**CONNECTICUT SITING COUNCIL
INTERVENOR STATUS REQUEST FORM**

Docket/Petition No. 364

Re: Docket 364: Waterford: The Connecticut Light and Power Company application for a Certificate of Environmental Compatibility and Public Need for the construction, maintenance and operation of a new bulk power 115- to 23- kV substation located at 325 Waterford Parkway North, Waterford, Connecticut.

3.1-1

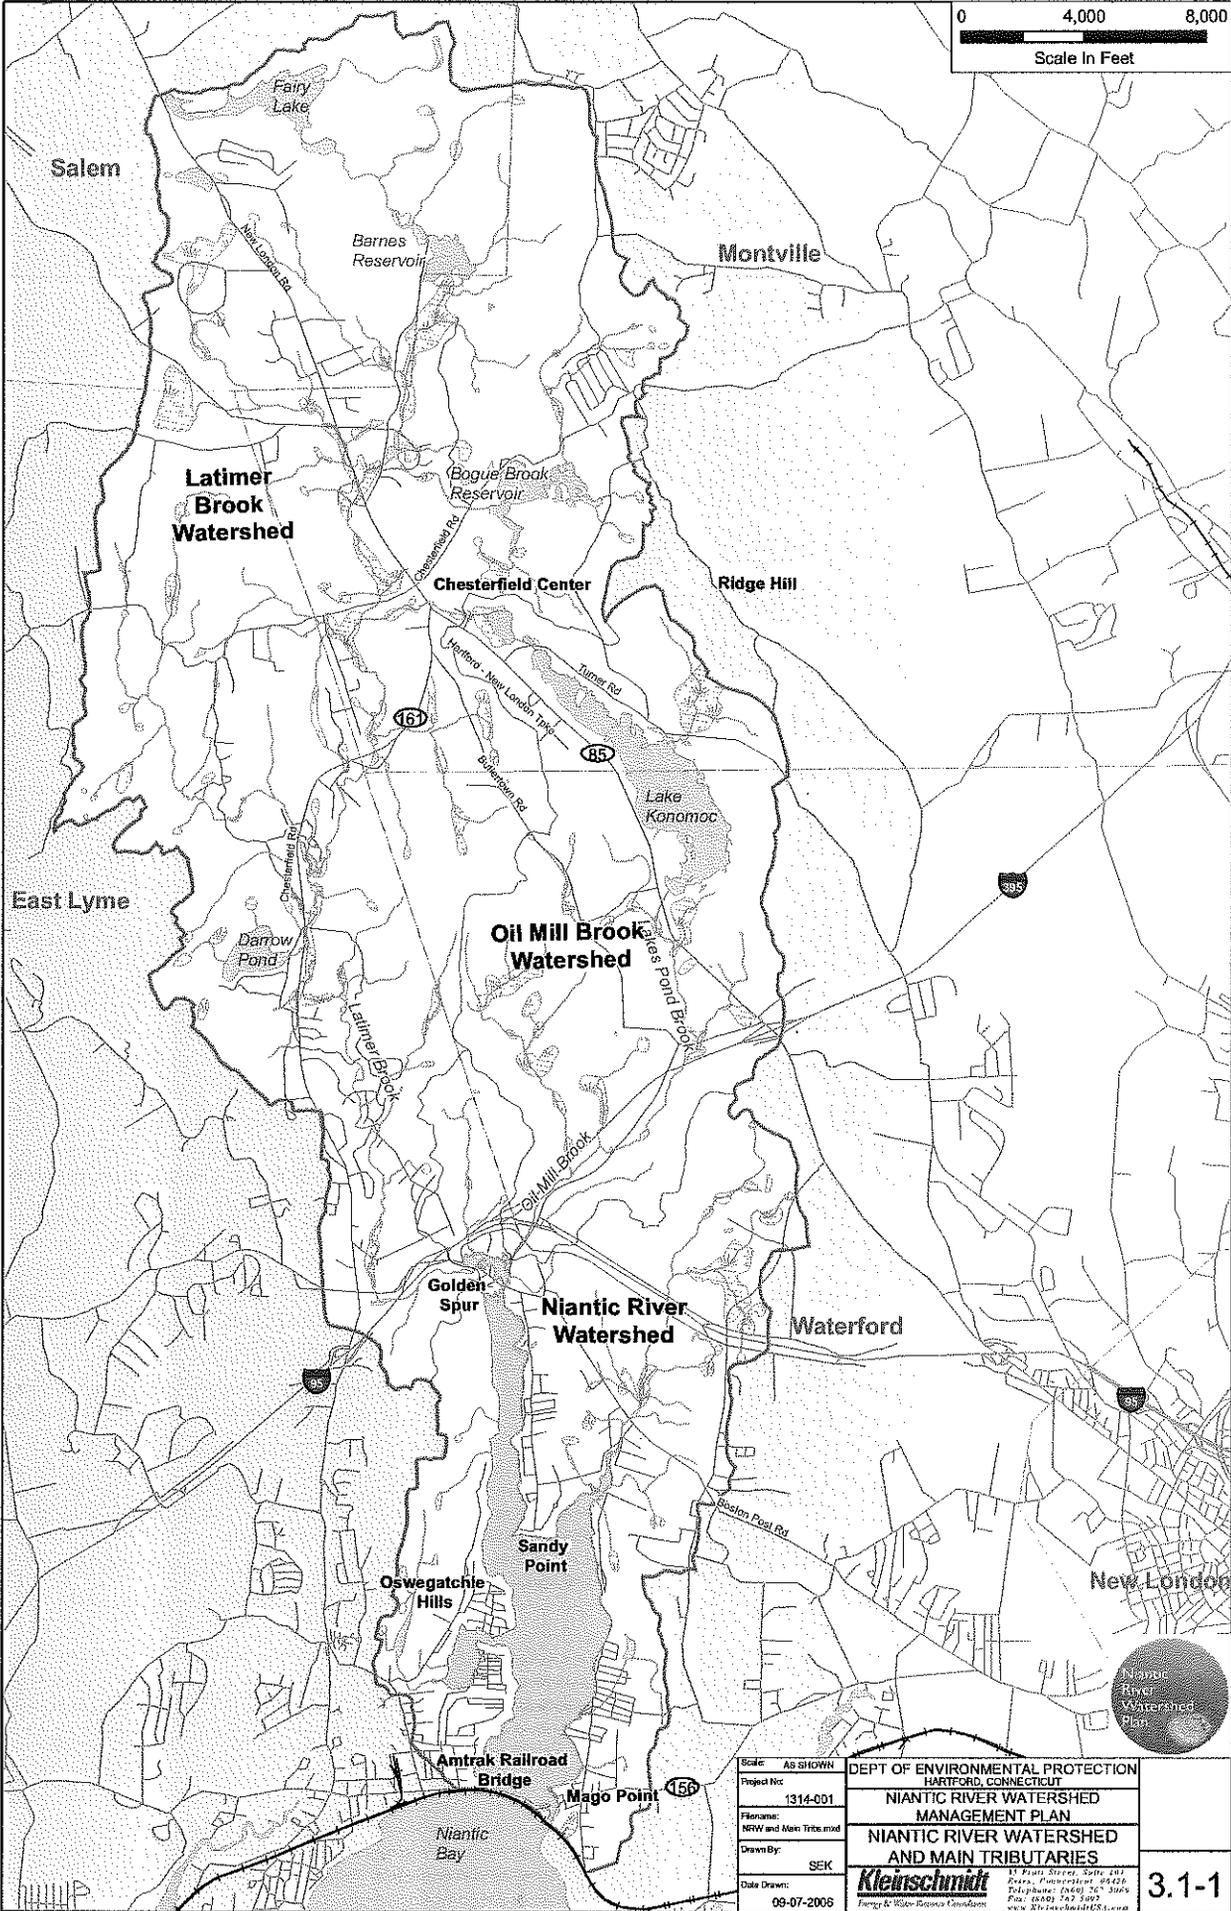
1. **It would appear site #1 is in the Niantic River Watershed based on the DEP, Niantic River Watershed Management Plan, Map #3.1-1(Exhibit enclosed) detailed at the DEP web site**

- a. **Why has this been omitted from all documentation?**
- b. **Have environmental studies been conducted regarding the impact to the Niantic River Watershed as a result of construction, operation, and maintenance of proposed facility? Please provide documentation available from those studies.**
- c. **An unnamed stream and associated wetland corridor are present running north and south in the east-central portion of the property. (re: Municipal Consultation Filing, date April 2008, page H-1). It would appear this stream, which is located 100' from the footprint, flows into the Niantic River. What provisions have been made for storm events and/or accident causing spillage of insulating oils and other materials into unnamed brook?**
